Change Notice

JW Series

Changes to Method of Identification on Switch Housing for JW Series Rockers

Changes to Identification on Switch Housing for JW Series

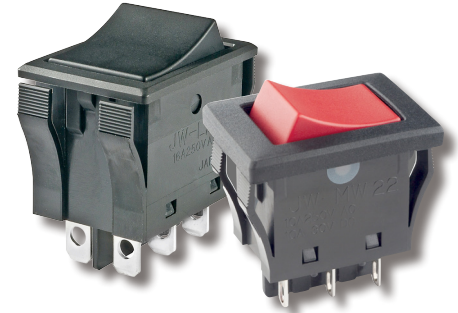
1. Sides of the switch housing for JWM, JWMW, JWL and JWLW models of the JW Series will reflect changes in the method of identification for their part number, factory code, lot code, and ON - OFF indications. Previously, the method has been engraving, but will be revised to laser etching. This change will apply to all standard and custom JW Series switches. Effected standard part numbers are on pages 3-7.

JW Series Rockers	Before Change	After Change
Method of Identification	Engraving	Laser Etching
